Southern Nuclear Operating Company
Vogtle Early Site Permit Application
Response to Request for Additional Information Involving
Limited Work Authorization-2 Supplement

Response to October 26, 2007 RAI Letter No. 9

Vogtle ESP Application Involving LWA-2

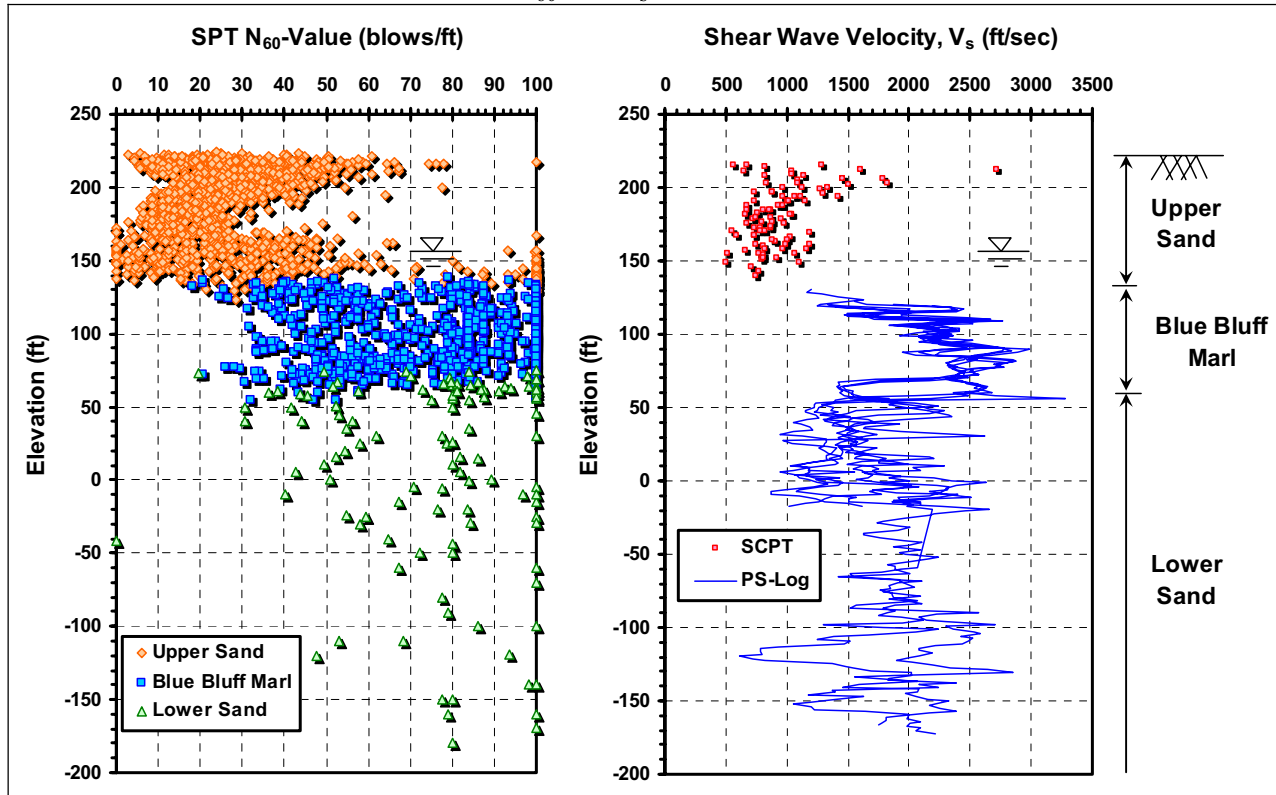
2.5.4-1 Section 2.5.4, page 1, indicates that 174 borings have been taken at the site along with other types of penetrations (presumably Cone Penetration Tests [CPTs], Suspension and dawn-hole velocity loggers, etc.). In reading through the other descriptions provided along with the MACTEC Appendices, the staff was unable to determine how the total of 174 was reached. SNC is requested provide a detailed accounting of these penetrations and how many penetrations will be unusable for the site specific analyses (e.g., because they were taken through material that is scheduled to be excavated).

In addition to the fourteen ESP borings described in Appendix 2.5A, Appendix 2.5C describes the 174 COL borings. The COL geotechnical investigation, with field work conducted between November 2006 and April 2007, included geophysical surveys and various subsurface penetrations. These penetrations consisted of 174 soil borings, 21 cone penetrometer test (CPTu) soundings, and 8 excavated test pits. The locations of these penetrations are illustrated on Figures 2.5.4-1a and 2.5.4-1b of ESP application Revision 2-S1. Generally, soil boring designators were assigned based on the subject of investigation. A summary is provided in the following table. The exploration depth of each boring varied depending on the existing ground elevation and the anticipated depth of influence of the structure. Exploration depths varied from 21.5 feet to 420 feet. SPT split barrel sampling was generally conducted on a five foot interval. One boring in each power block area was sampled continuously.

Seventy soil borings (two of these were shallow offset borings due to near surface obstructions) were located in the immediate vicinity of the combined excavation footprint for the Units 3&4 power blocks. These included 9 of the 1100 series borings, 32 of the 3000 series borings, and 29 of the 4000 series borings. With the exception of the two offset borings, each of these borings was drilled through the Upper Sand and into the Blue Bluff Marl (BBM). Forty-two of the 70 borings penetrated the BBM and extended into the Lower Sands (LS). Six borings penetrated the underlying Still Branch Formation and two borings penetrated the Congaree Formation. Both of these formations are located in the upper portion of the LS strata. Suspension soil velocity measurements along with resistivity, spontaneous potential, and natural gamma data were obtained in the six deep borings. Caliper and boring deviation data were also collected in these deep borings.

Twenty-one CPTu soundings were taken across the site including four in the combined power block footprint, six in the area of the cooling towers, and the others in roadways and pipeline areas. The data collected at each of these soundings included tip resistance, sleeve resistance and pore pressure dissipation measurements. Eight of the 21 soundings were conducted as seismic cone penetrometer tests

(SCPTu). These soundings were located in the combined power block/cooling tower area. In addition to the CPT data, compression and shear wave velocity data were collected in the SCPTus. Due to the dense/hard layers encountered at the interface of the Upper Sand and Blue Bluff Marl strata, the soundings could not penetrate into the Blue Bluff Marl. Generally, CPTu and SCPTu data collection was limited to the Upper Sand stratum.

Shear Wave Velocity Measurements in the Upper Sand Stratum Measured by COL SCPTu

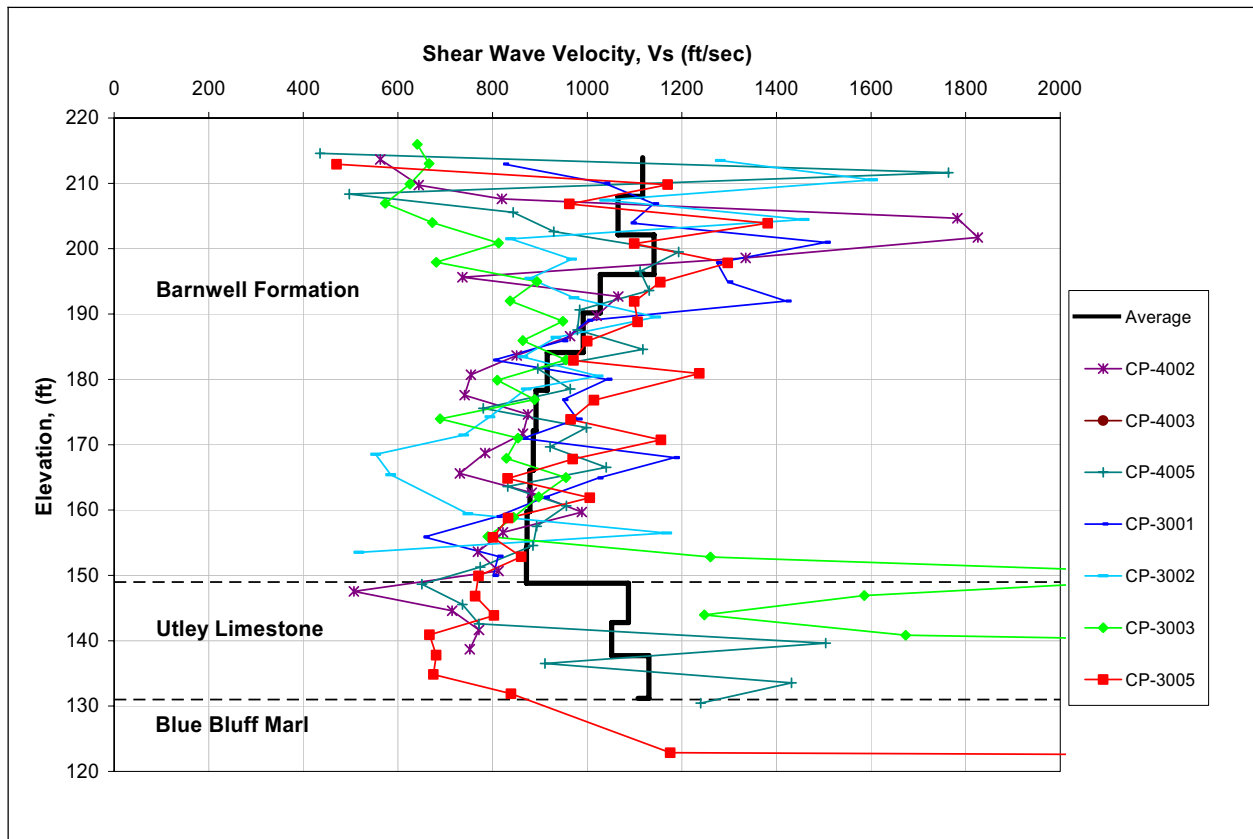
2.5.4-4 Section 2.5.4.2.2.1 indicates that no new strength (and presumably stiffness) testing is to be performed for the Upper Sand Strata since this material is being excavated from beneath the Category I structures. Without additional information, the staff cannot verify SNC's conclusion on the effect of the two-dimensional velocity configuration of the excavated zone on site response and SSI effects. SNC is requested to provide the assessment of the in-situ velocity profile through the Upper Sand Strata for the staff to complete its evaluation.

Shear wave velocity data were collected in the Upper Sand in the power block/cooling tower area. Eight SCPTu soundings were taken as described in the above response to RAI 2.5.4-1. The shear wave velocity measurements from seven of these soundings along with the average velocity profile are presented on the figure below. The data from the eighth sounding, C-4001, was not plotted and incorporated into the average value. In this sounding velocity values of 4,000 fps were encountered at the top and bottom of the US stratum and the data were judged to be unreliable.

Plot of N_{60} and Fines Content with Elevation – Borrow Area 4

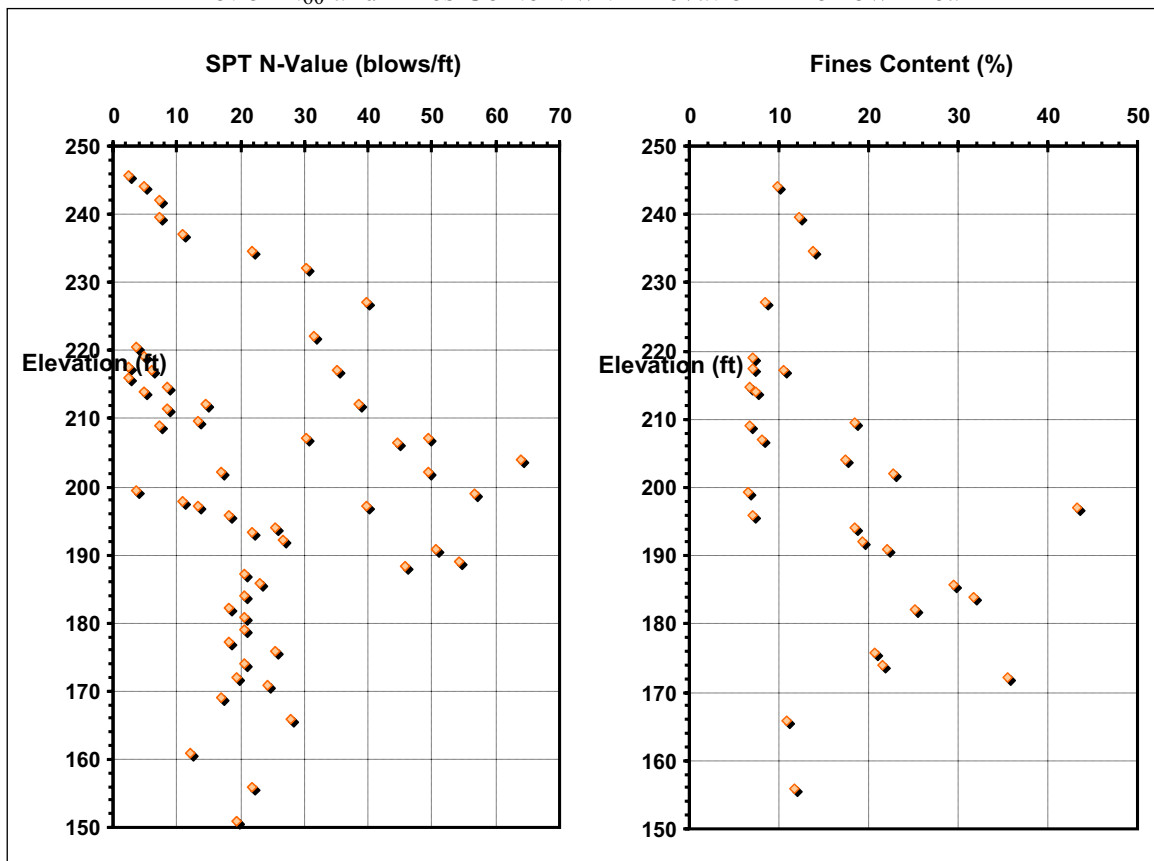
2.5.4-10 Section 2.5.4.5.3 states that approximately 3.9M cubic yards of material will be excavated for the power block area and that approximately 3.8M cubic yards will be required as structural backfill. Only about 30% of the excavated material will be suitable for reuse as structural backfill. An additional 2.5M cubic yards will be required and therefore, SNC is requested to perform additional investigations and testing, using horizontal and vertical intervals sufficient to determine material variability of the borrowed soil.

During the Units 3 & 4 COL geotechnical investigation, the alternative borrow source, Borrow Area 4, located about 4,000 feet north of the power block area was explored with four SPT borings and three test pits. This area was previously explored but not utilized during the design and construction of Units 1 and 2. Results of the COL field and laboratory test are summarized in the figures and table below.

Presentation of test results for soils at Borrow Area 4: (a) SPT N_{60} -value; (b) Fines content (MACTEC, 2007).

Modulus Reduction Curves for EPRI and SRS Models

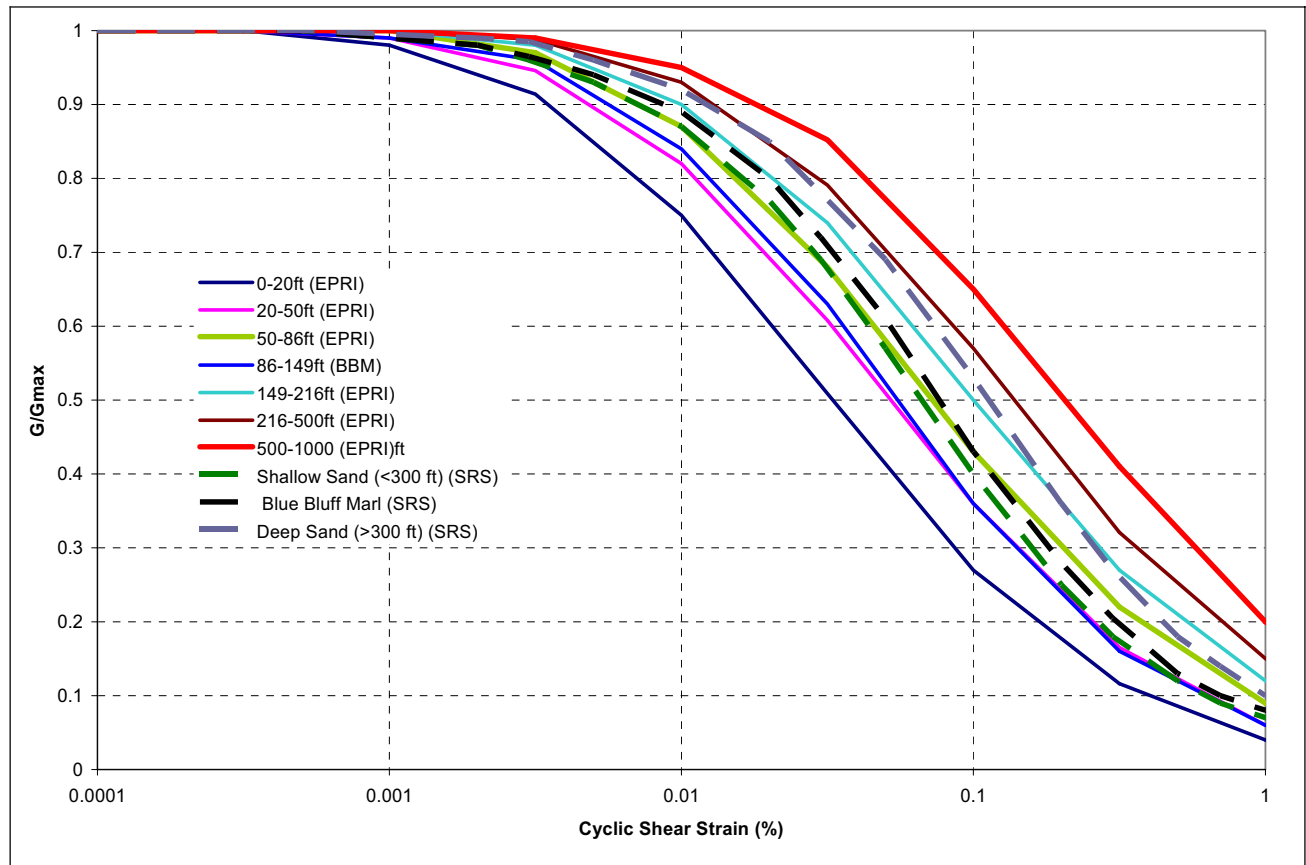
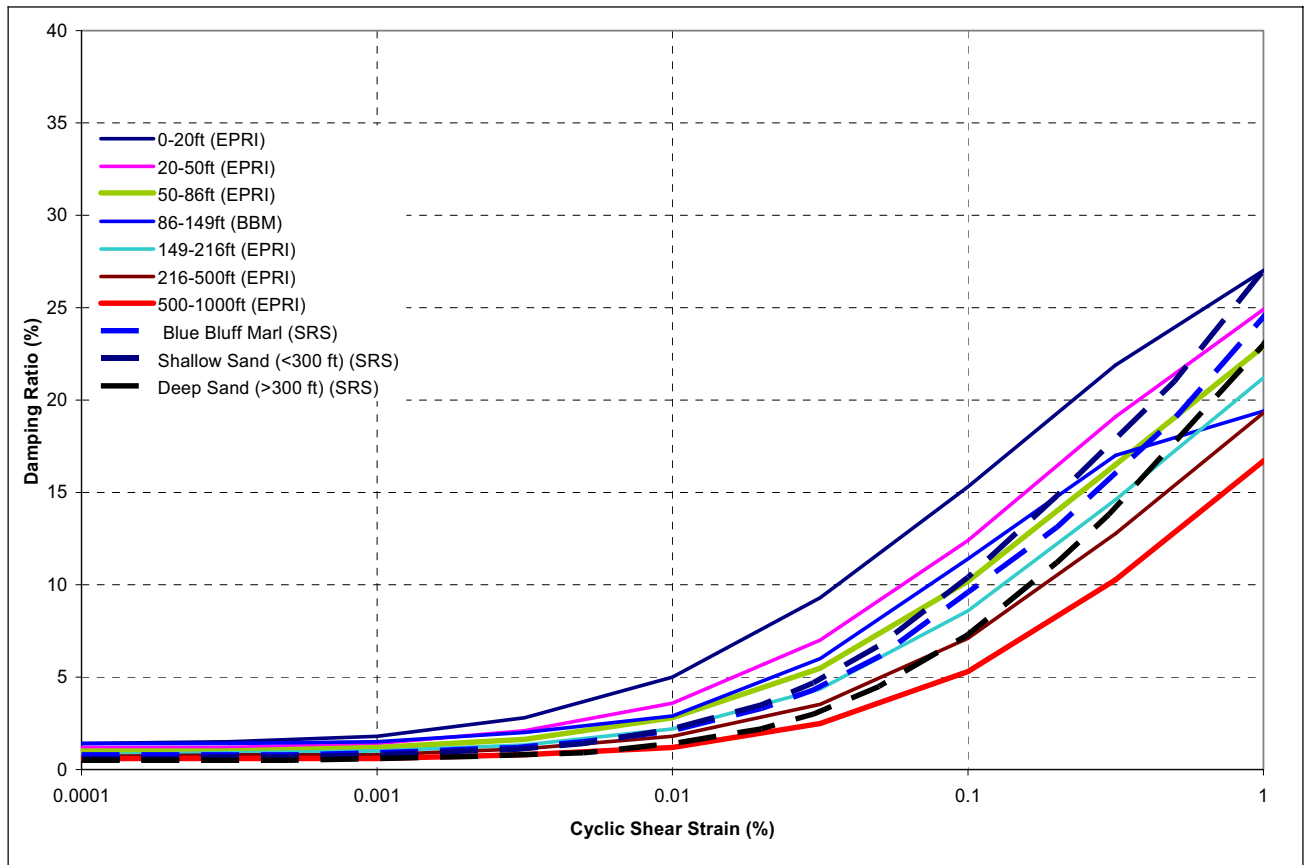
2.5.4-16 In Subsection 2.5.4.7.1, SNC discussed the shear wave velocity profile to characterize the site, but the discussion did not cover the backfill material. In Subsection 2.5.4.7.2, SNC described EPRI 1993 soil degradation models as well as SRS models. However, no significant discussion is presented of how these two models compare, which is more appropriate to use for Vogtle site response analyses, and how significant the models are to both site response and SSI analyses. SNC is requested to address these three issues.

2) ESP application Subsection 2.5.4.7.2 discusses shear modulus and soil damping for the compacted backfill, BBM, and Lower Sand strata. These subjects were further discussed in the March 15, 2007 response to RAI 2.5.4-17. These discussions included descriptions of which EPRI curves were used to derive the soil degradation values for input to the SHAKE analysis. Soil degradation values from the neighboring SRS site were also used for input to SHAKE. Figures 2.5.4-9 and 2.5.4-11 in the ESP application illustrate the EPRI soil degradation values, while Figures 2.5.4-10 and 2.5.4-12 illustrate the SRS soil degradation values. The modulus reduction curves for EPRI and SRS have been plotted together in the figure below to illustrate the relationship between these models. Likewise, the same has been done for the damping ratio curves. Note that the SRS curves were selected based on their stratigraphic relationship to the Vogtle 3 and 4 site. The SRS curve labeled as Blue Bluff Marl on the figures below is

based on the Dry Branch Formation and the Santee Formation, the SRS stratigraphic equivalent to the Vogtle Blue Bluff Marl. Both data sets were used to include variability in the model and each is weighted equally. RCTS testing is currently being conducted to develop site-specific data. When these data become available, the results will be evaluated and the site response analysis will be re-run if appropriate.
